**Re: Flatiron Meadows Planning Area C Preliminary Plat, Amendment No. 2  
Comment Response Letter**

**FLATIRON MEADOWS – PLANNING AREA C  
PRELIMINARY PLAT REVIEW RESPONSE**

# FLATIRON MEADOWS PRELIMINARY PLAT, AMENDMENT NO. 2

**FLATIRON MEADOWS**  
 PRELIMINARY PLAT  
 OVERALL SITE PLAN

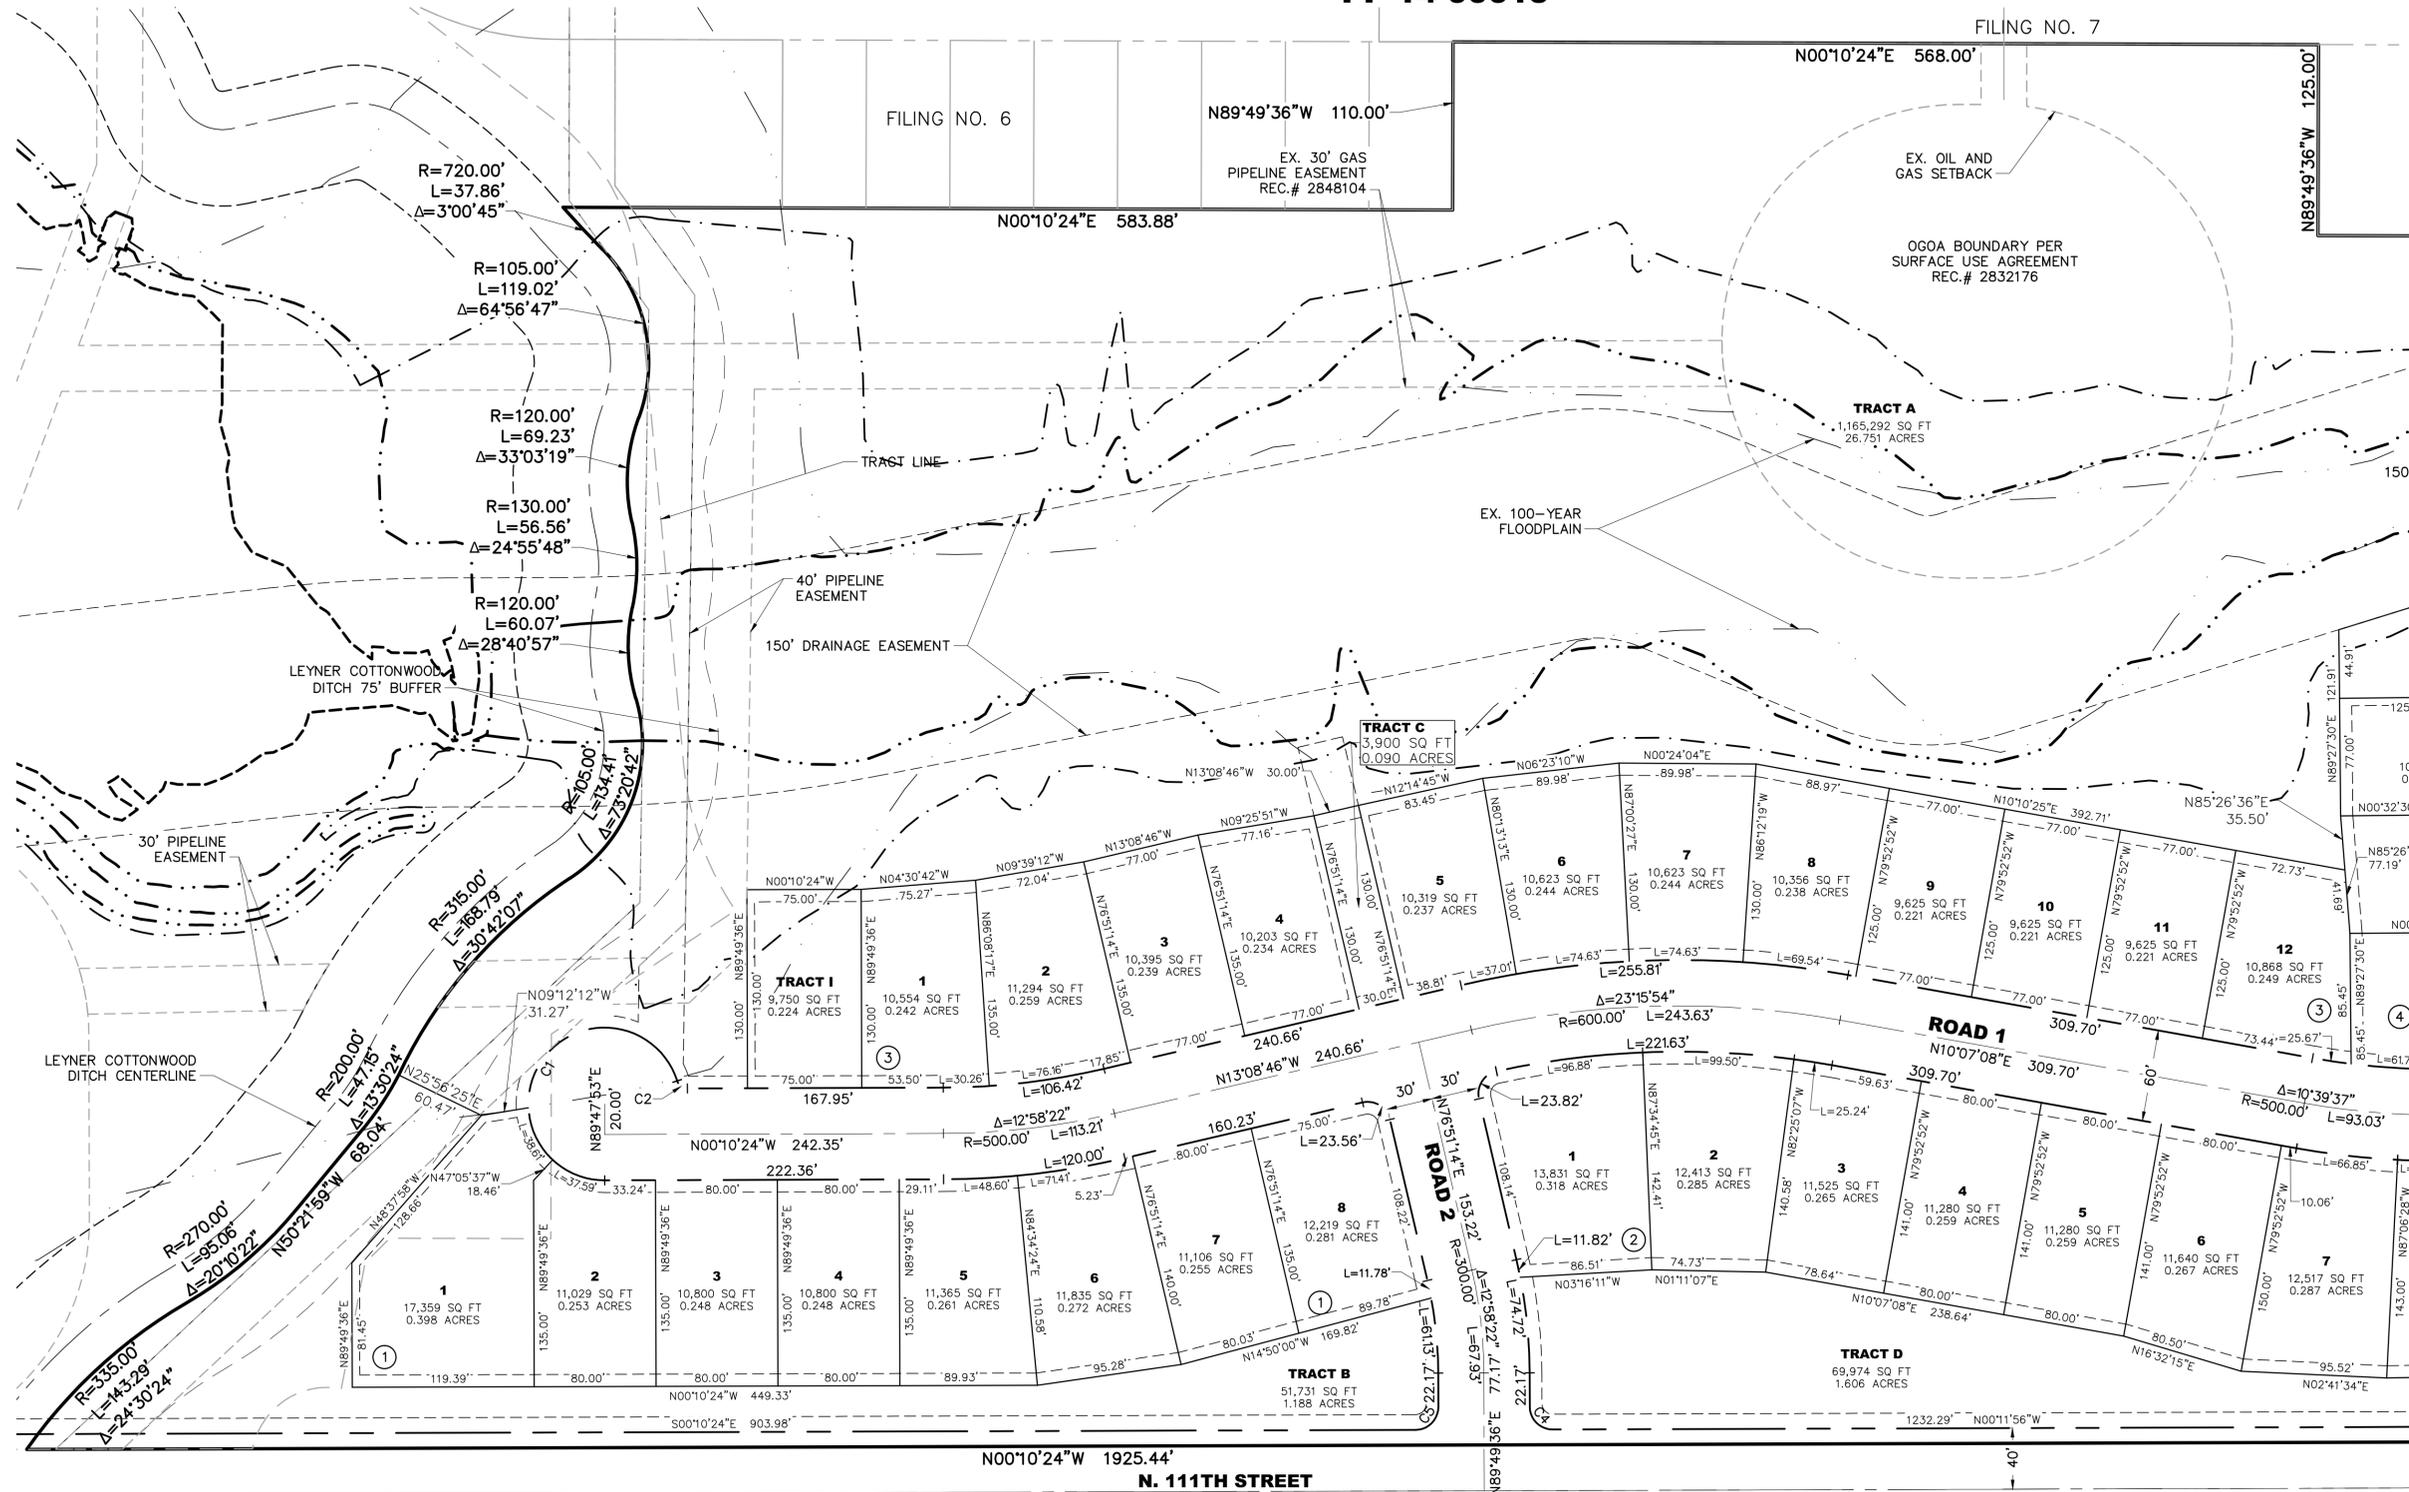
8. Sheet SP1 – Site Plan 1
  - a. The grayscaled line on this sheet shows the limits of the Lots and Open Space from the approved Preliminary Plat No. 1 for comparison. Lot 5, Block 8 encroaches too far past the previous plat limits and further narrows the narrowest portion of the open space corridor. Delete Lot 5 or adjust to the south and west to match previous preliminary plat. Please delete  
*Response: This row of lots has been adjusted to minimum lot sizes and the knuckle has been removed to gain open space east of lot 5.*

- b. Tract E is called out as the Pocket Park. It extends out into the flood plain, dam breach, and drainage easement limits. Adjust boundaries of Tract E to be located outside of the 150' drainage easement limits.  
*Response: The boundary of Tract E has been adjusted to be outside of the drainage easement.*

Sheet	12
<b>SP2</b>	of 13
Date	JANUARY 27, 2017

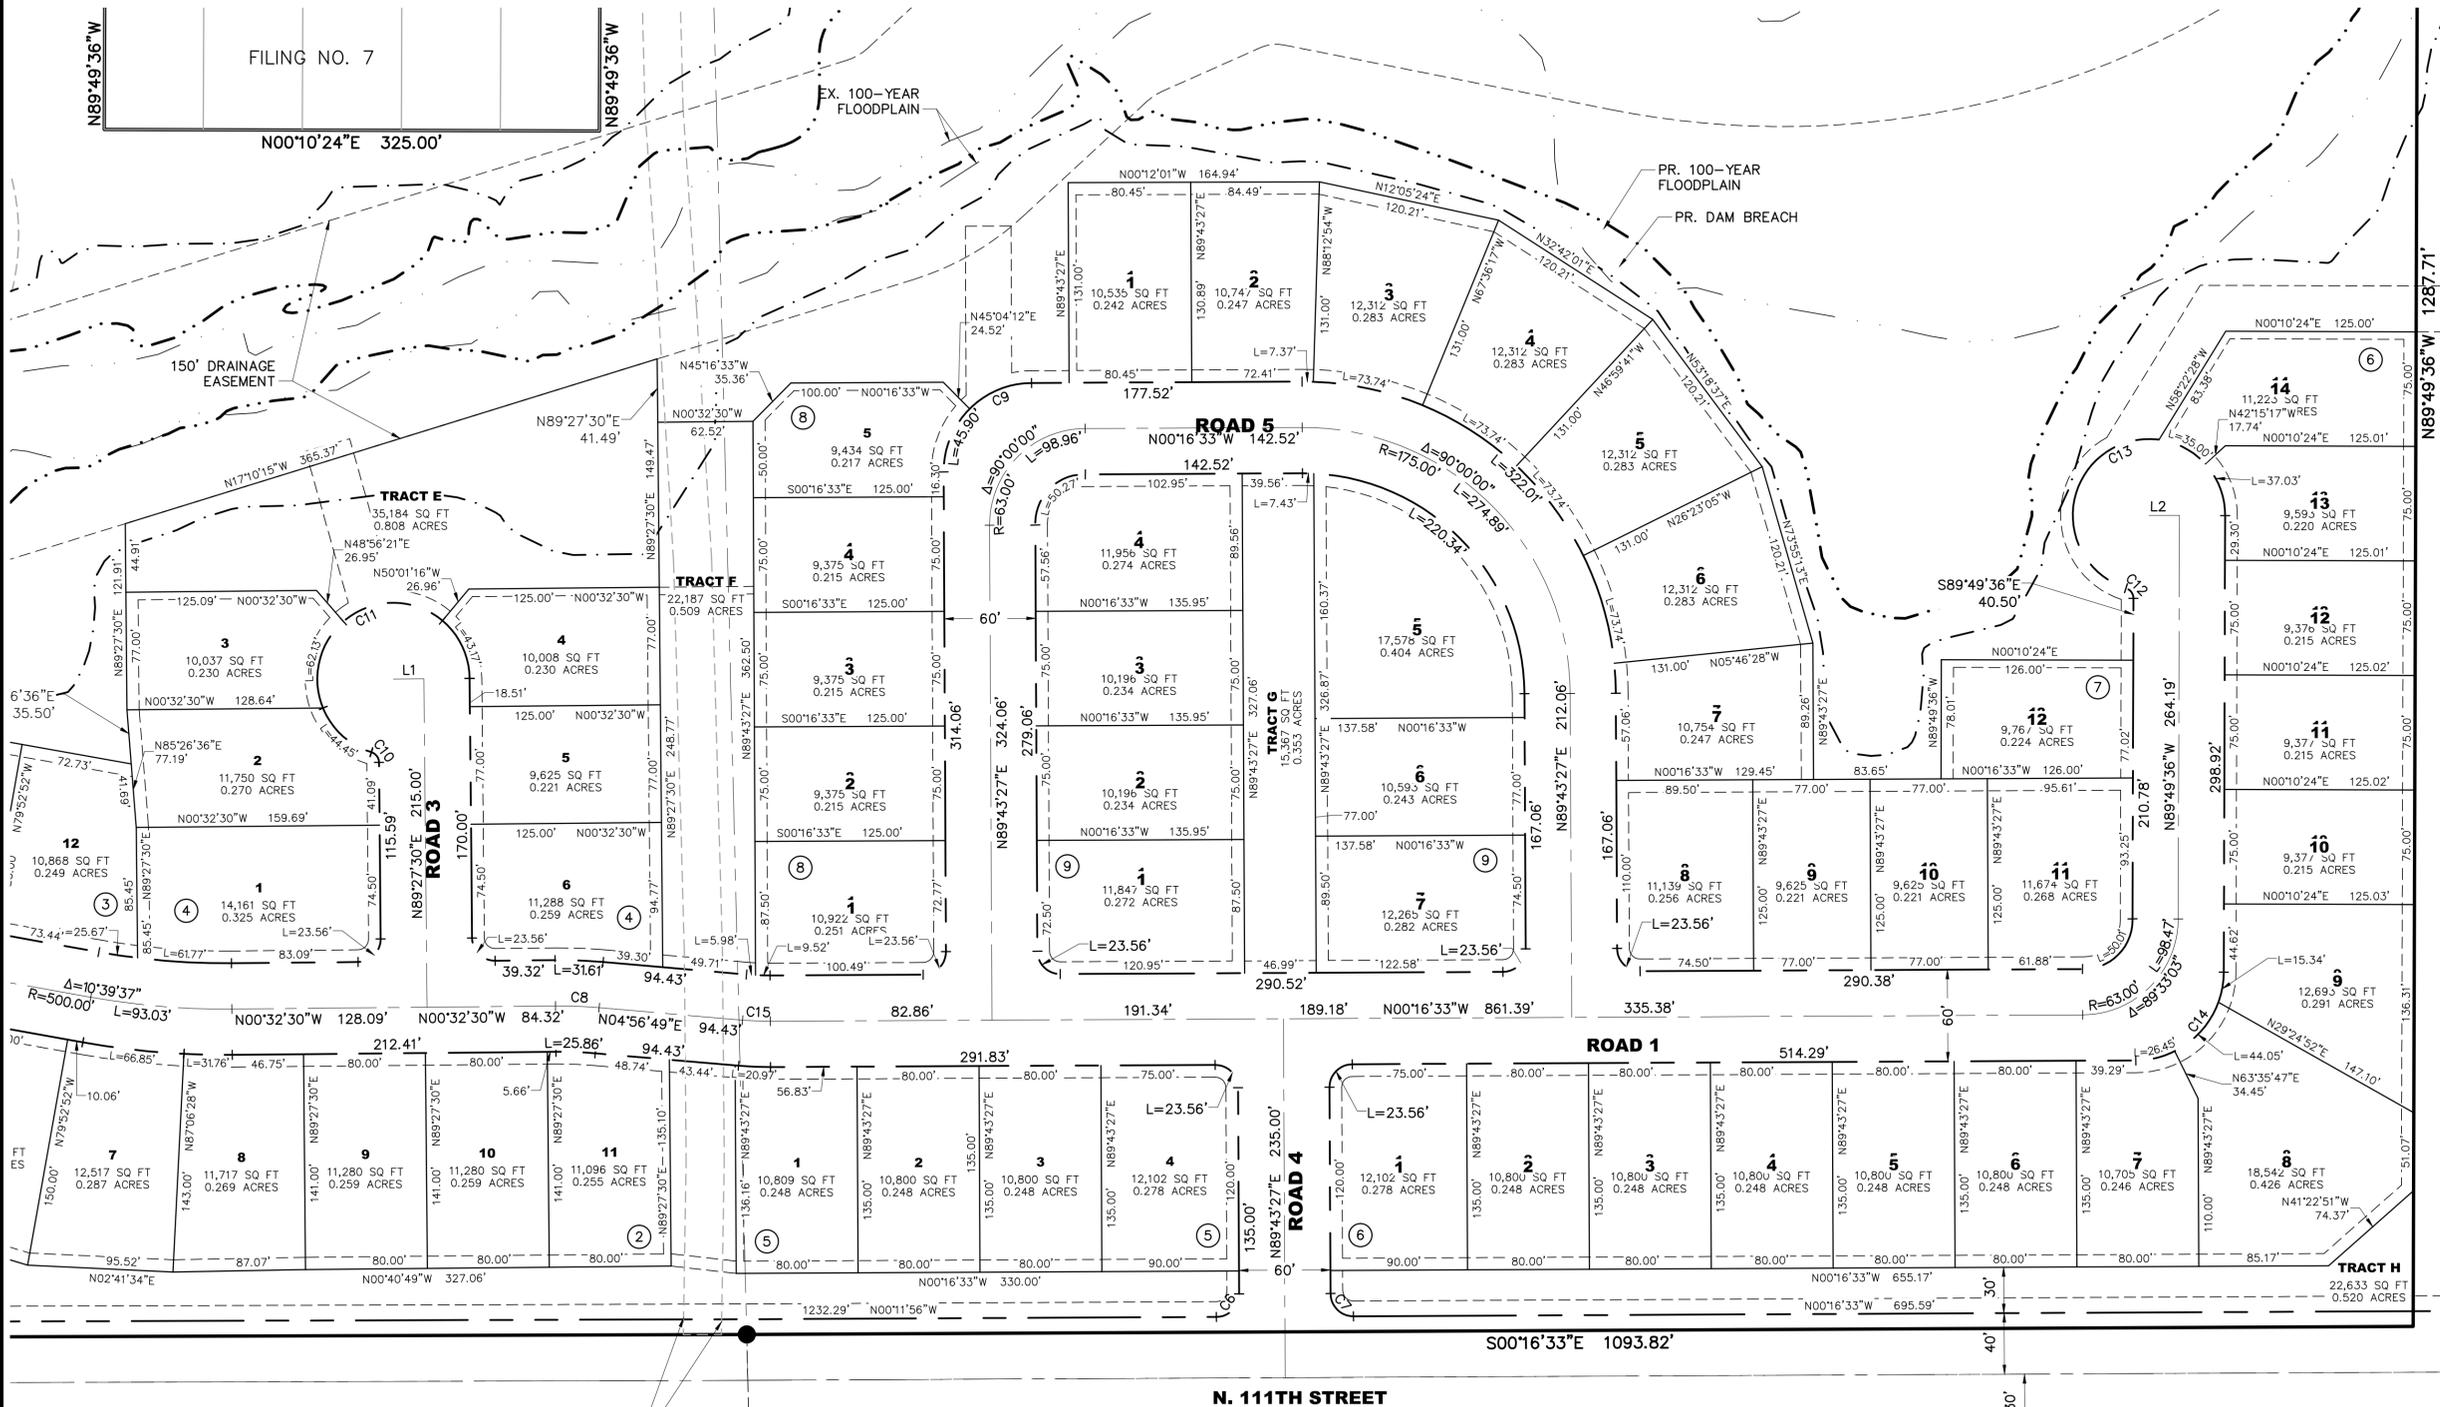
9. Sheets SP2 & SP3 – Site Plan 2 & 3
  - a. Lot 1, Block 1 is a flag lot and prohibited by the UDC. The lot must meet the minimum lot width requirements (80') at the front setback line (25' into the lot). Lot 1 doesn't achieve its minimum 80' width until ~120' into the lot from the cul-de-sac ROW. You may be able to adjust the bulb/curvature of the cul-de-sac to increase the street frontage of Lot 1 and as a result the setback line is in the wider portion of the lot. You also may be able to modify the side lots lines of Lots 2-5 to gain some width for Lot 1.  
*Response: The configuration of the cul-de-sac and lots have been revised per Town redlines.*

- b. Old Comment: Delete Tract G and extend adjacent lots to back to each other. If the applicant desires a feature/terminus at Road 4's intersection with Razorback lane, a small tract could be preserved and landscaped. Otherwise, staff's opinion is that Tract E's small size and lack of programming/design will be a maintenance burden on the HOA and a source of complaints by adjacent property owners/residents. 1/18 update: Per Comment 8.a above, the layout of lots in this area may change. Maintenance concern still valid.  
*Response: The open space tract is highly desired by the home builder. They would prefer to keep the tract between the lots.*
